ADA Curb Ramp New Construction Inspection Form (Perpendicular)

Nw 289

24952.54

Nw union

PERPENDICULAR RAMP (PR)

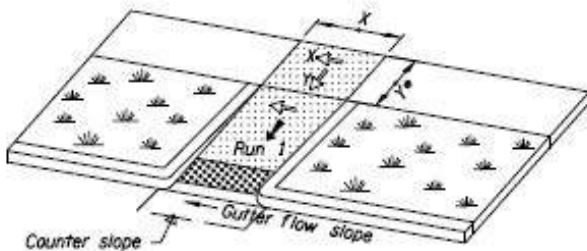
IITD RR1 fail
